**ADDENDUM NO. 5
IRONDALE PUBLIC LIBRARY**

CITY OF IRONDALE

THIS ADDENDUM FORMS A PART OF THE CONTRACT DOCUMENTS. THE FOLLOWING CONDITIONS TAKE PRECEDENCE OVER ANY CONFLICTING CONDITIONS IN THE DRAWINGS AND SPECIFICATIONS. THE DRAWINGS AND SPECIFICATIONS ARE HEREBY AMENDED IN THE FOLLOWING PARTICULARS.

E201

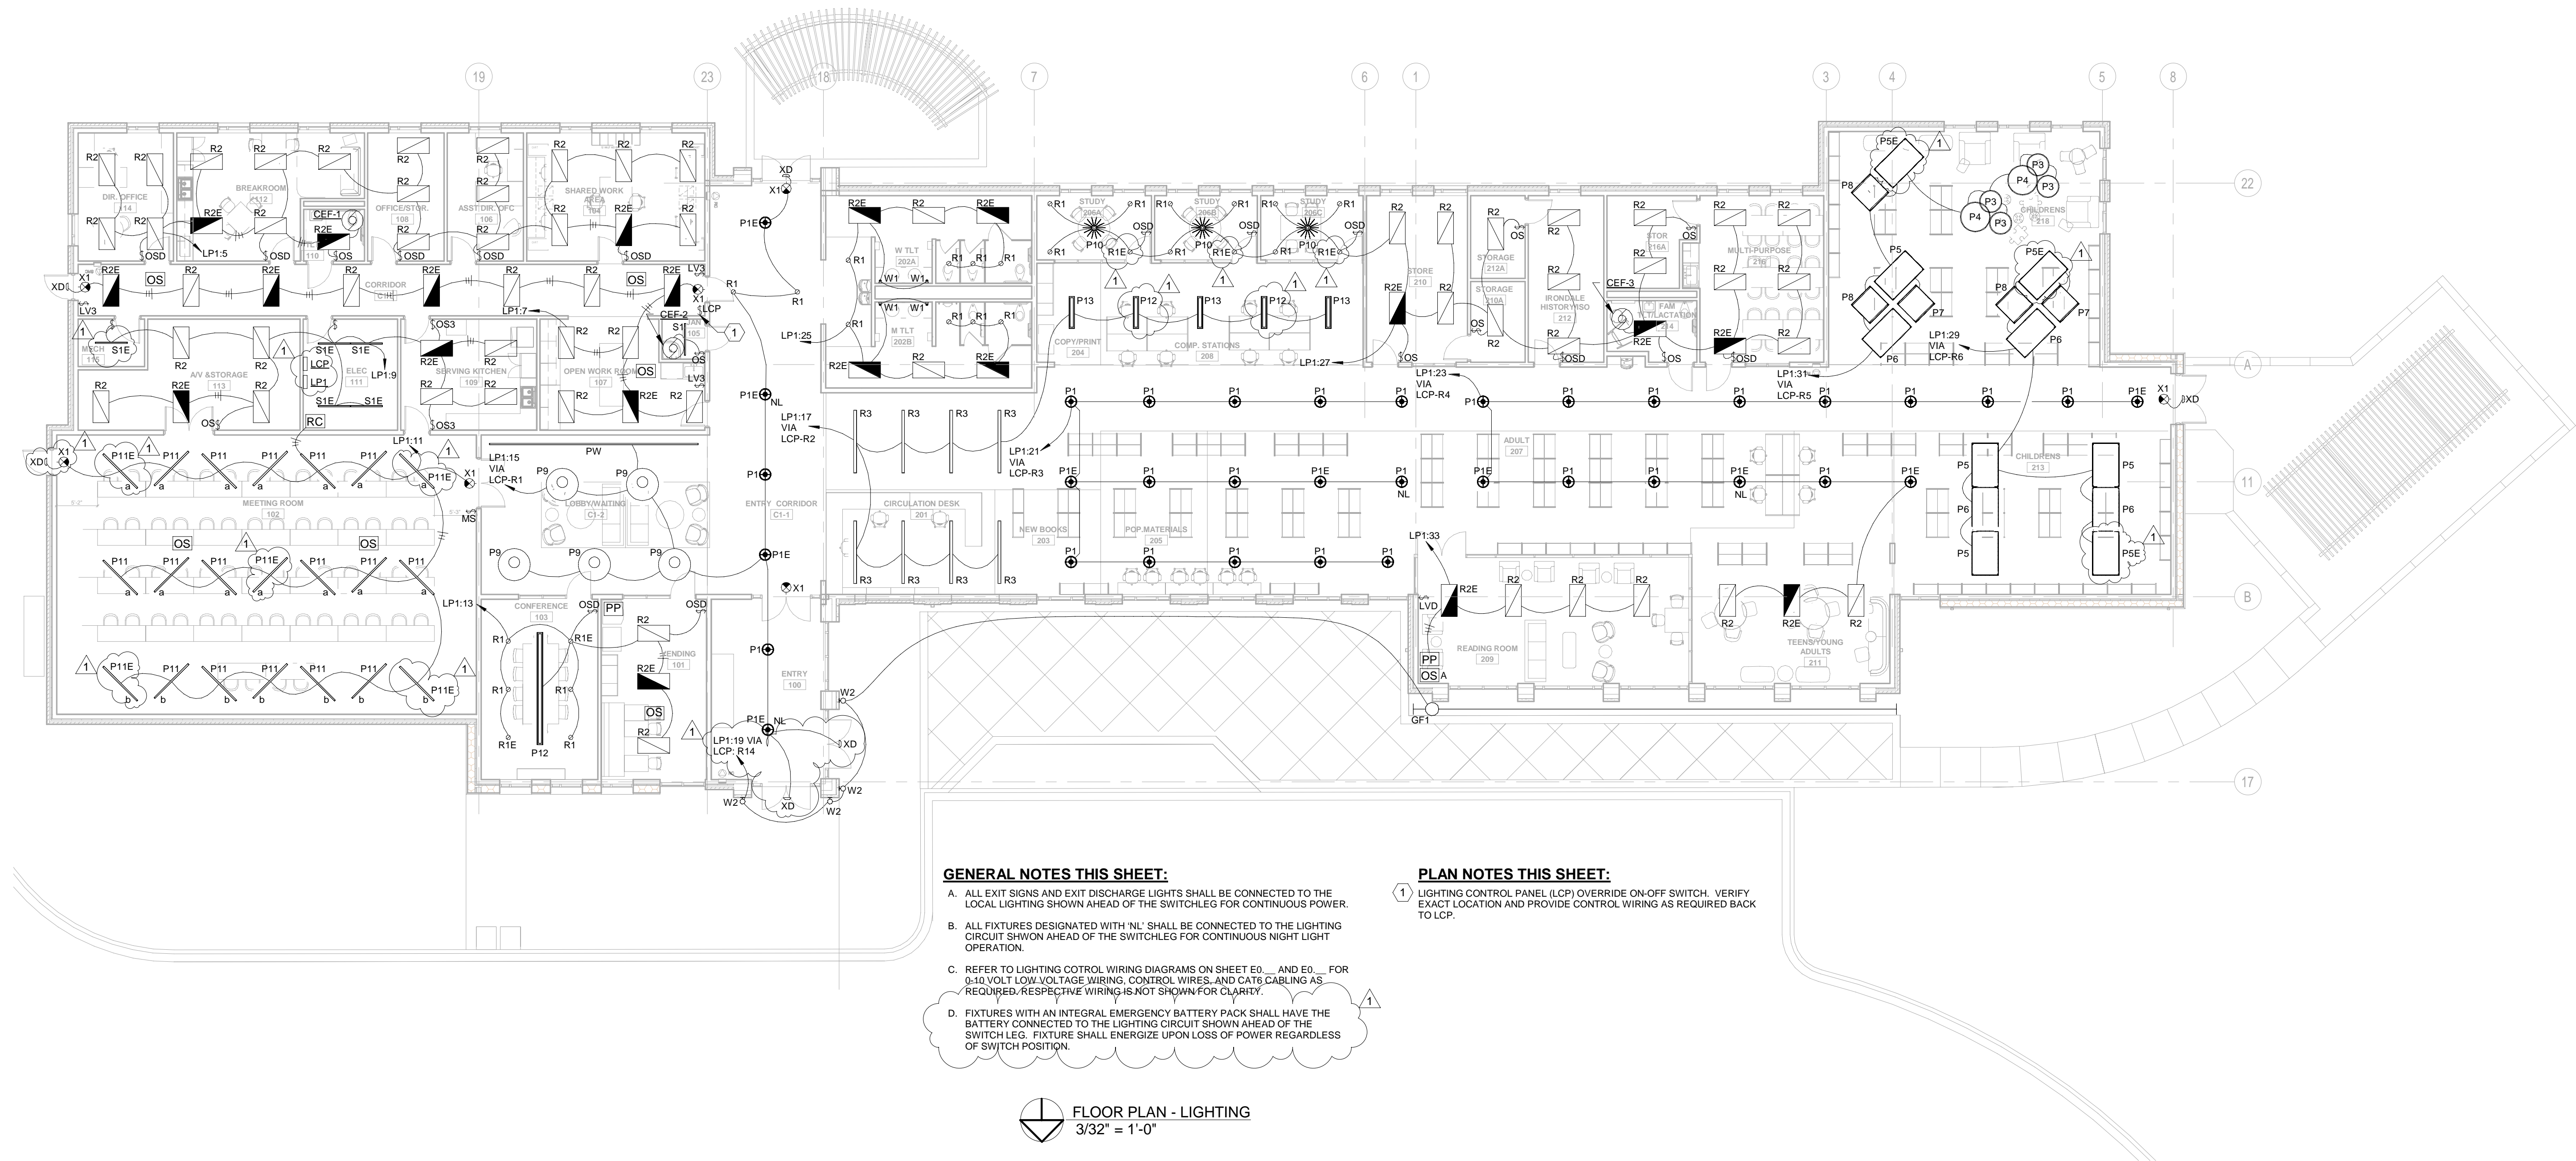
- a. Moved monumental sign. Coordinate the exact location with the civil drawings.
 - b. Updated circuiting requirements for the site.
- 12. Sheet E201
 - a. Light fixture designations modified to reflect additional fixtures that will require battery back-up.
 - b. Removed two (2) exit signs at entry lobby.
 - c. Added General Note 'D'.
- 13. Sheet E202
 - a. Added cabling requirements for Wireless Access Points.
 - b. Added plan note designations to floor boxes that were not identified.
- 14. Sheet E203
 - a. Added duct mounted smoke detectors at roof top unit as required.

Response: Added on attached revised sheets.
- 4. Light fixture type 'W2' quantity of (4) shown on the exterior of the building at entry 100 on electrical drawing E201 is not listed on the lighting schedule on electrical drawing E002. Please provide a part number.

Response: Added on attached revised sheets.
- 5. Light fixture type 'P13' as shown in comp. station 208 on electrical drawing E201 does not appear to be 14' long as noted on the lighting schedule on electrical drawing E002. Please clarify.

E203

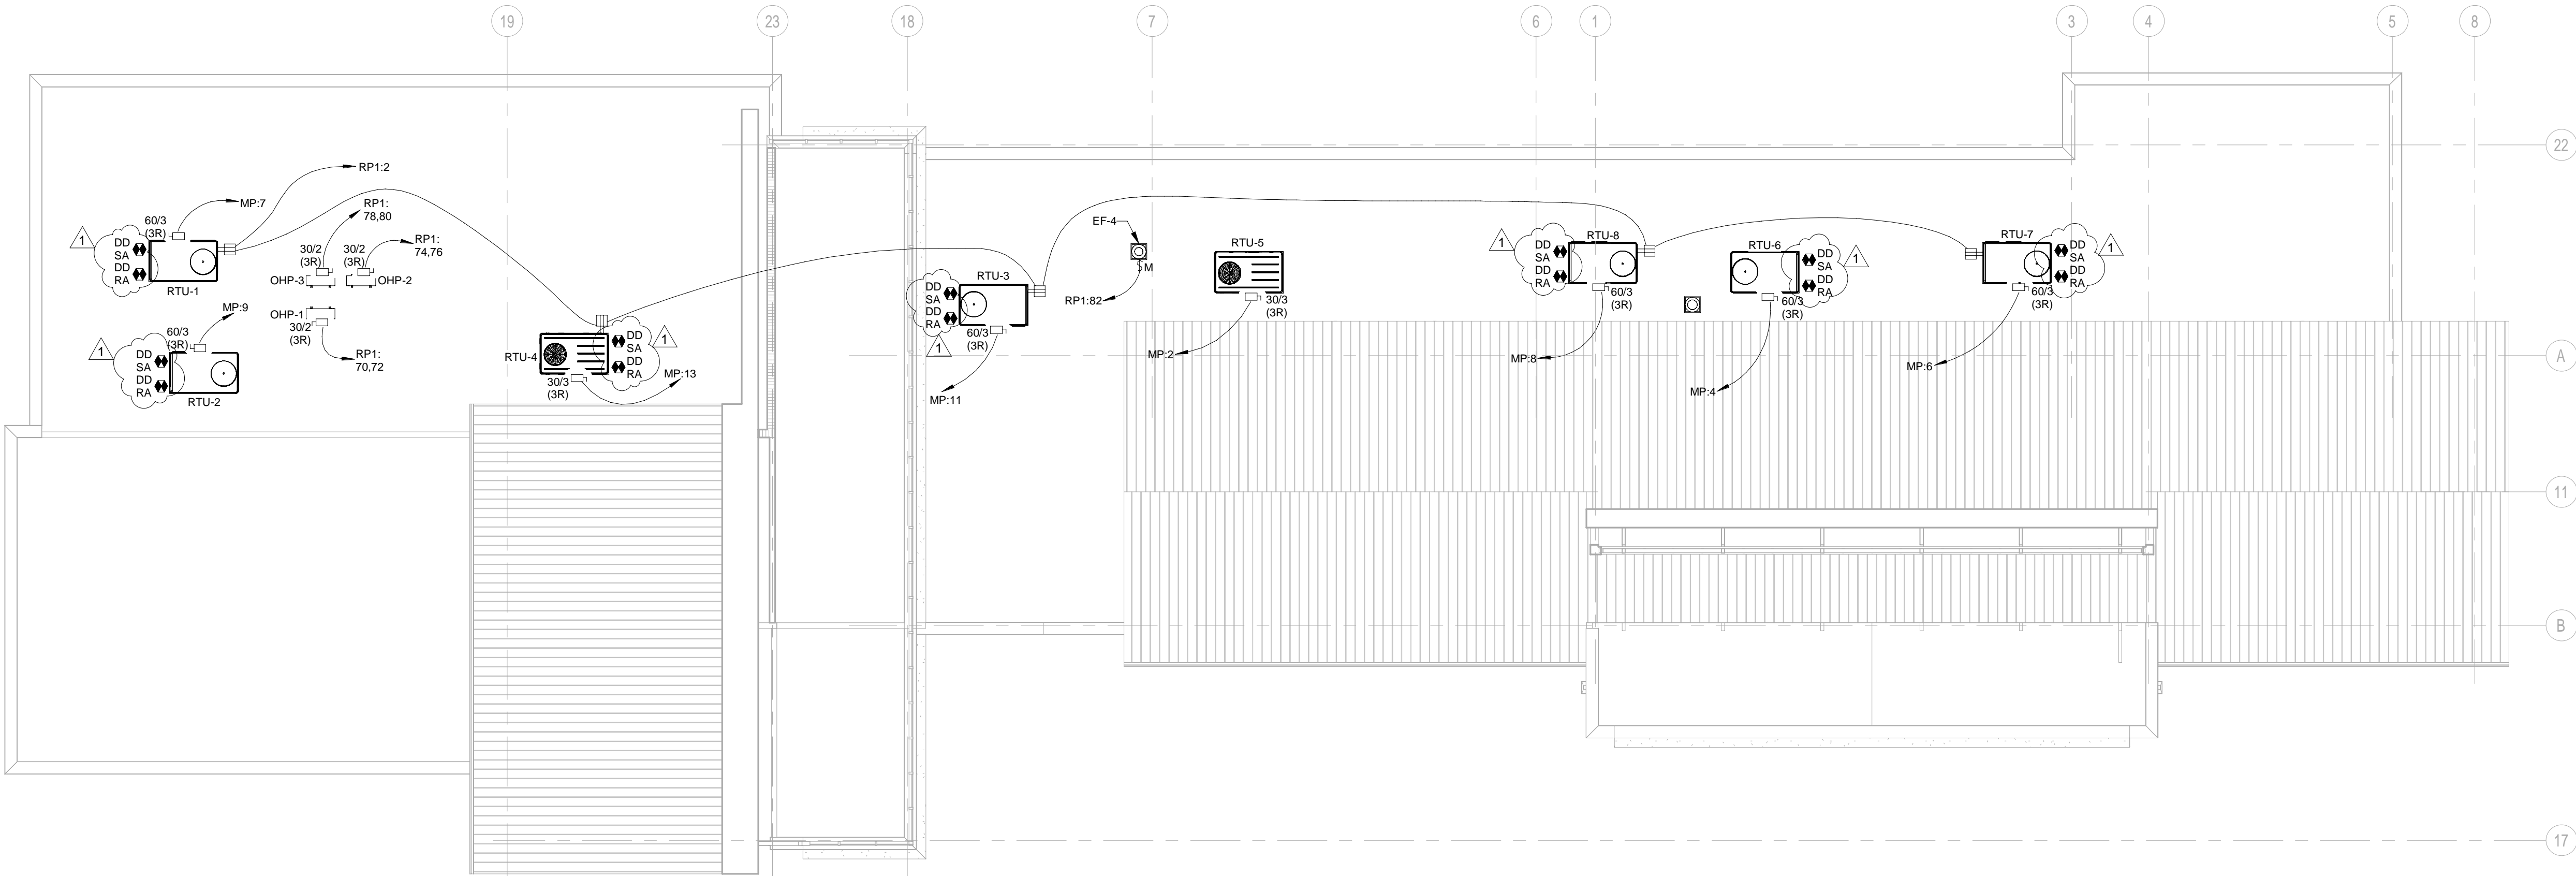
- 1. Per the mechanical drawings RTU's 1, 2, 3, 6, 7, and 8 are the only units over 2000CFM. Will these be the only units requiring duct detectors and should they be on both the supply and return?

Response: Duct detectors to be provided by electrical and installed by mechanical. Duct detectors required on supply and return ductwork at RTU-1, 2, 3, 6, 7, and 8.
